This addendum is issued by the Owner to all known bidders prior to receipt of Proposal. Bidders shall acknowledge receipt of this Addendum by so indicating on the Proposal Form. All information and instruction given herein shall become a part of the Contract Documents.

PHOENIX ACADEMY OMAHA
APMA Project # 15008
7 August 2015

ADDENDUM # 2

PROJECT Phoenix Academy Addition and Renovation

C1.0

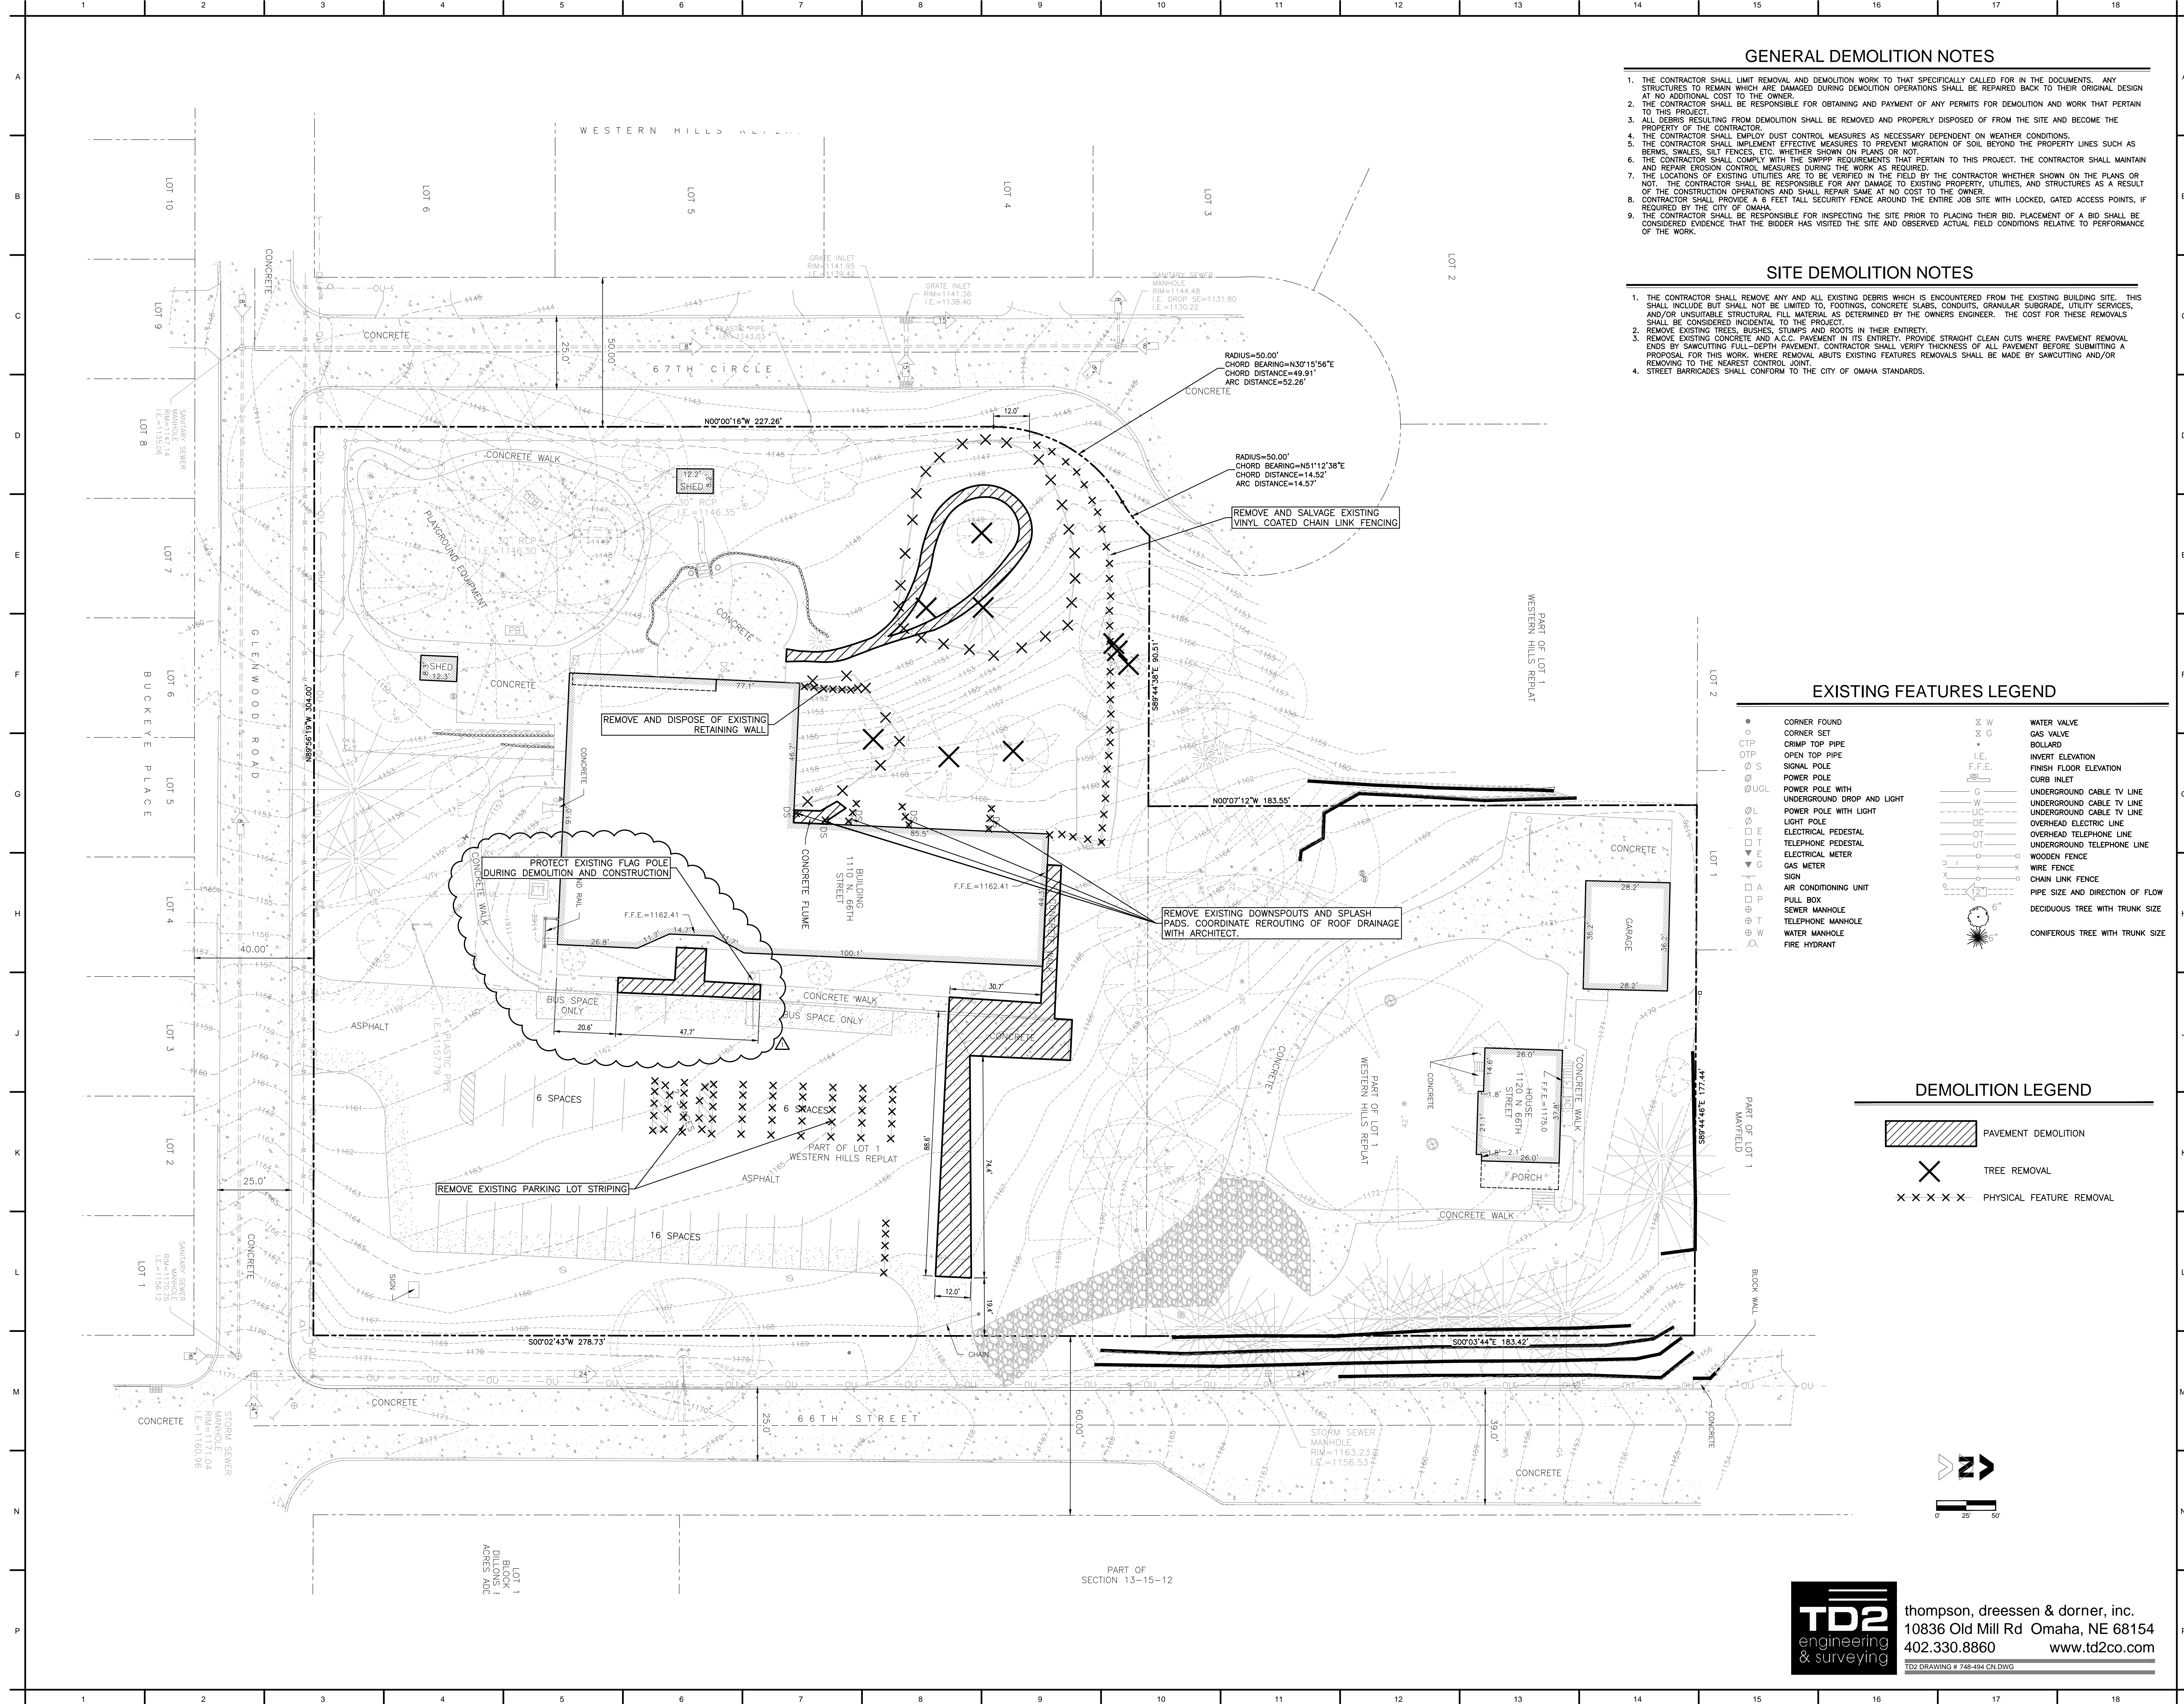
- 1. SHEET C1.0 – DEMOLITION PLAN
- 2. SHEET C3.0 – SITE UTILITY PLAN
- 3. SHEET C4.0 – SITE PAVING PLAN

DEMOLITION PLANS - LOWER LEVEL & FIRST FLOOR

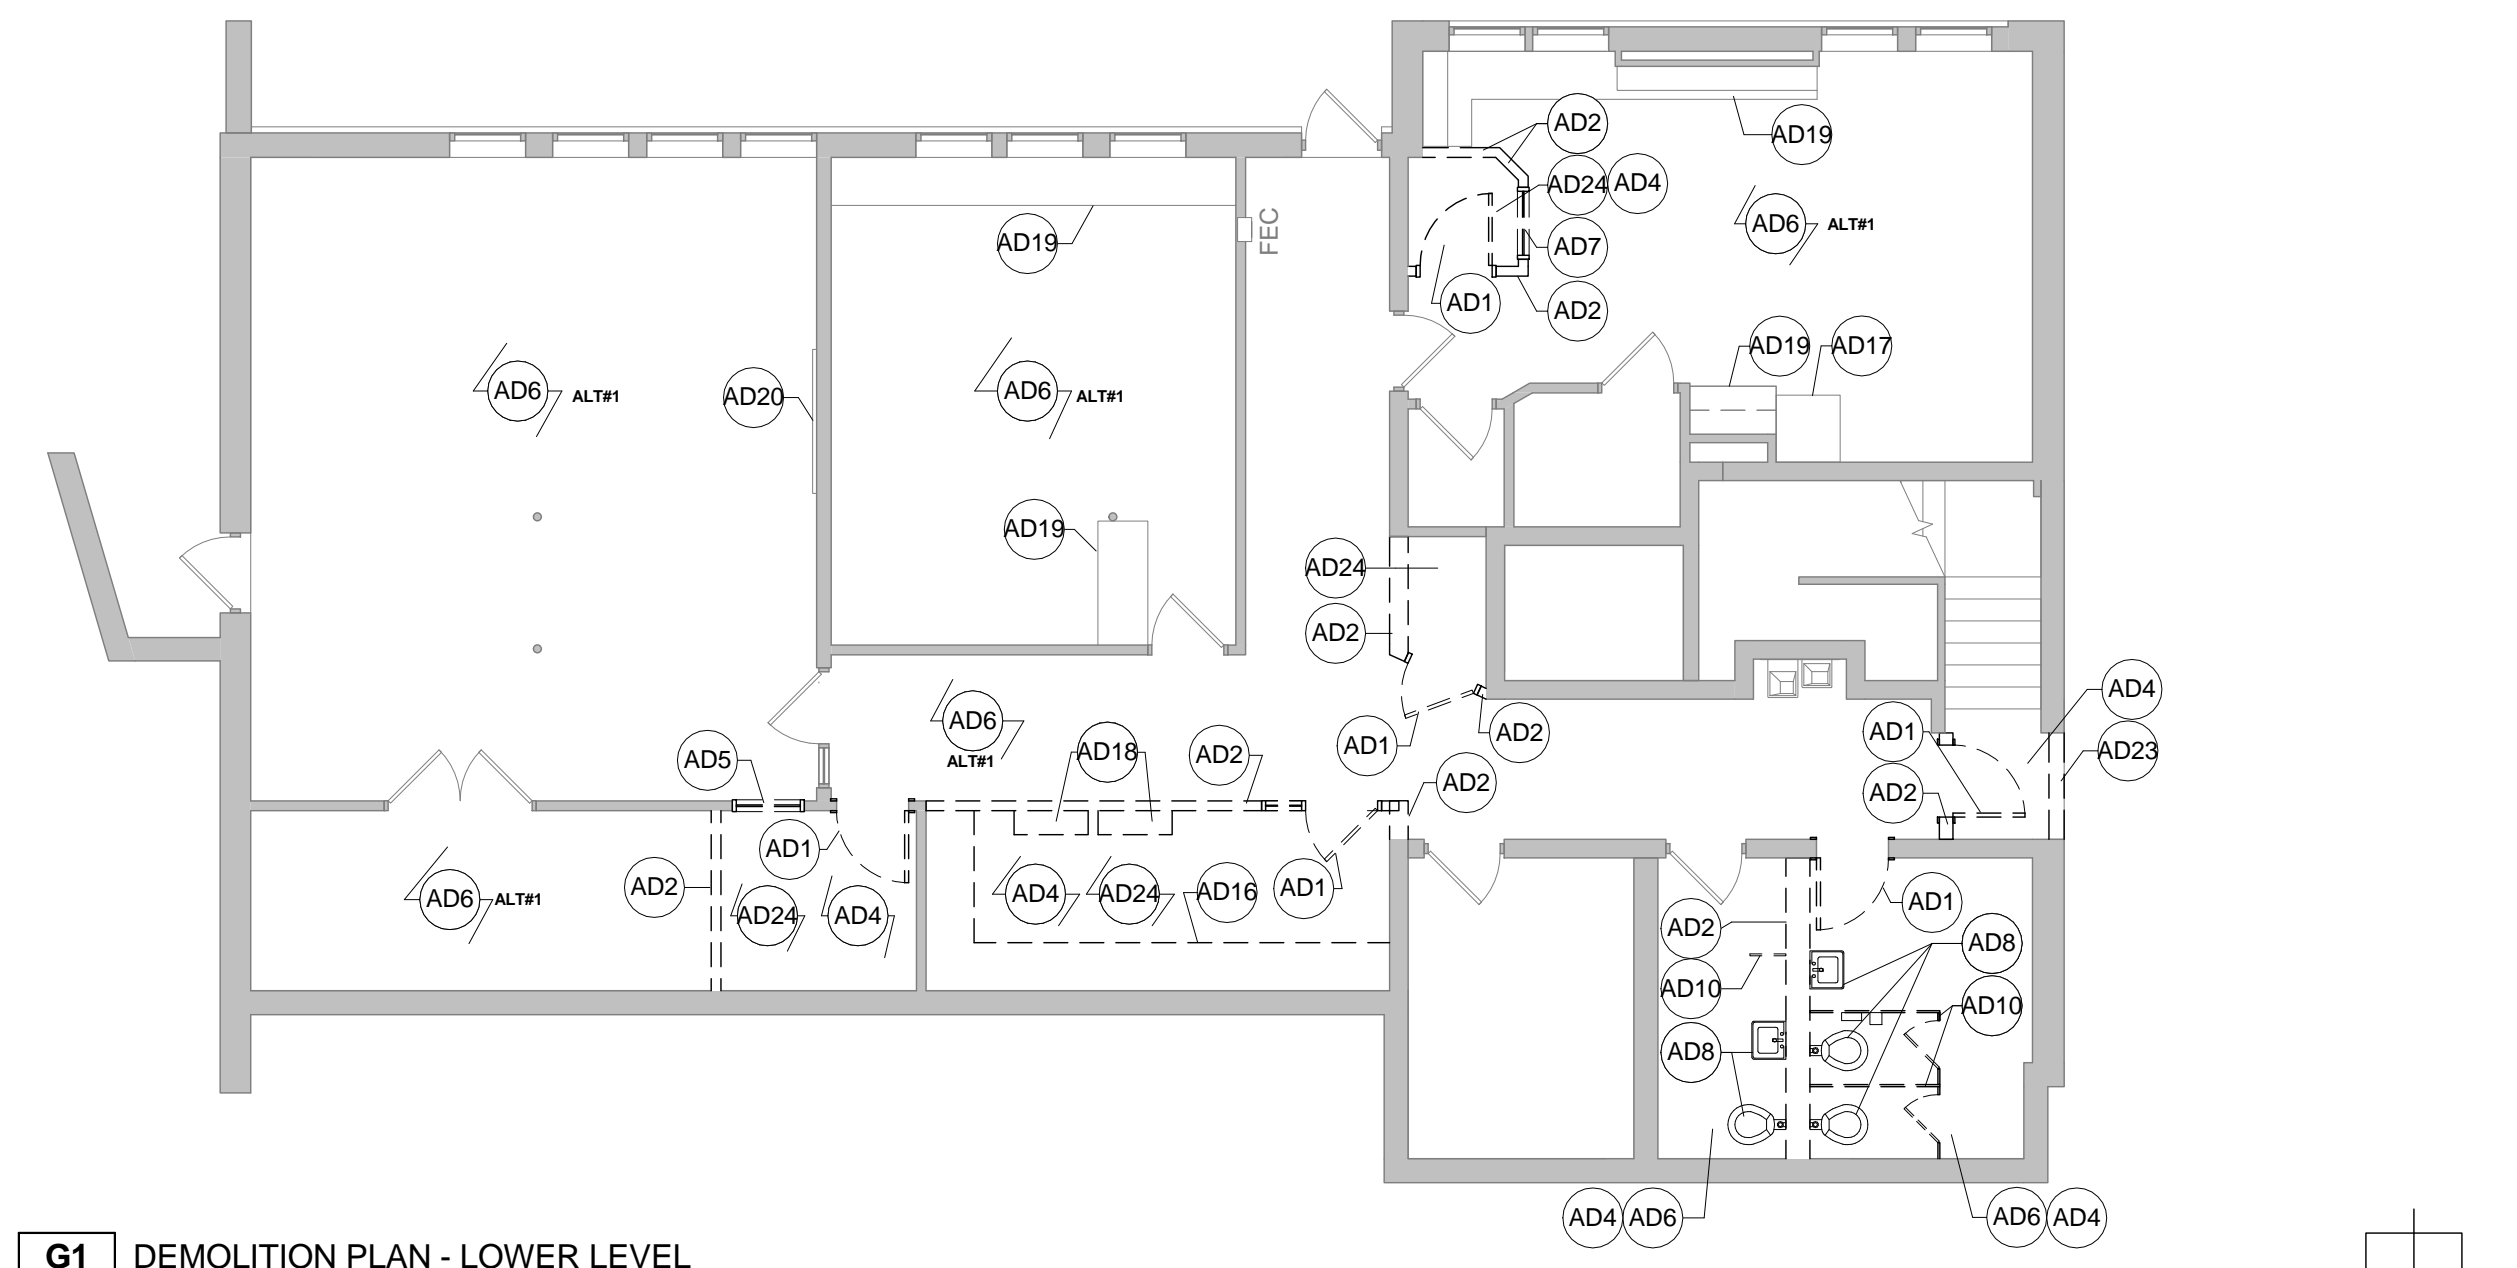
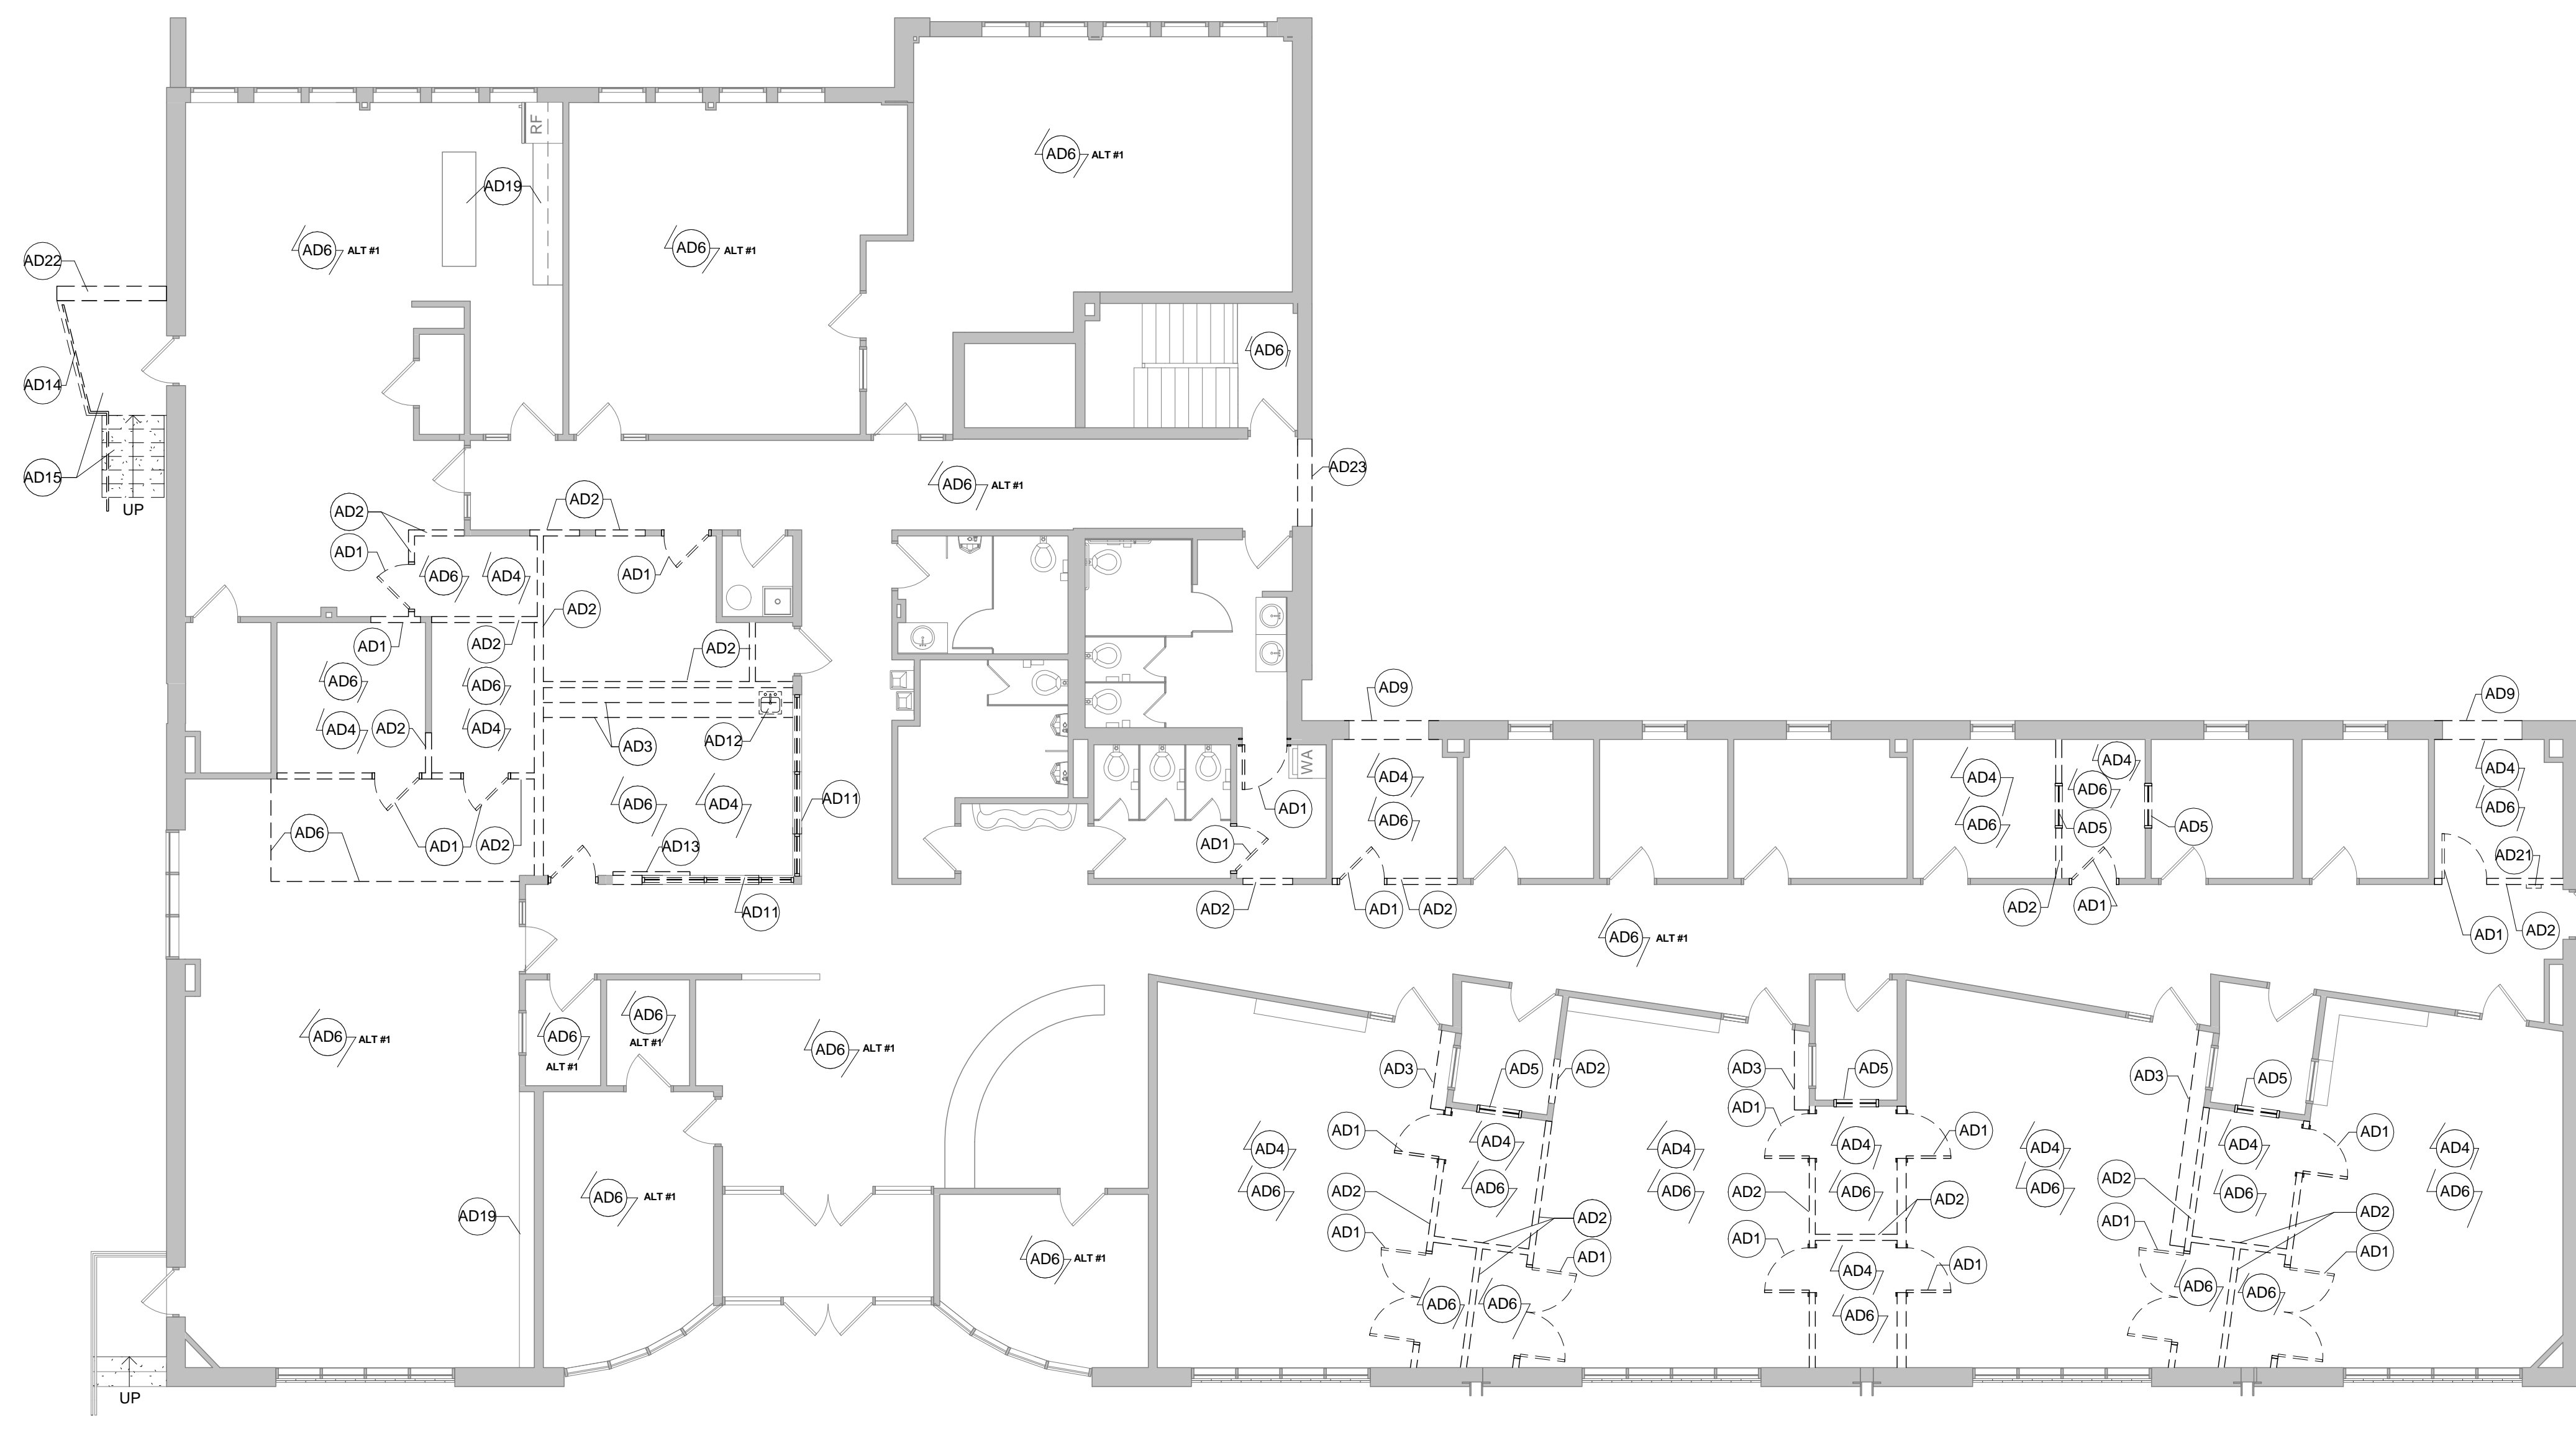
- 1. SHEET AD1.0 – DEMOLITION PLANS – LOWER LEVEL & FIRST FLOOR
- 2. SHEET A9.1– FINISH PLANS – LOWER LEVEL & FIRST FLOOR
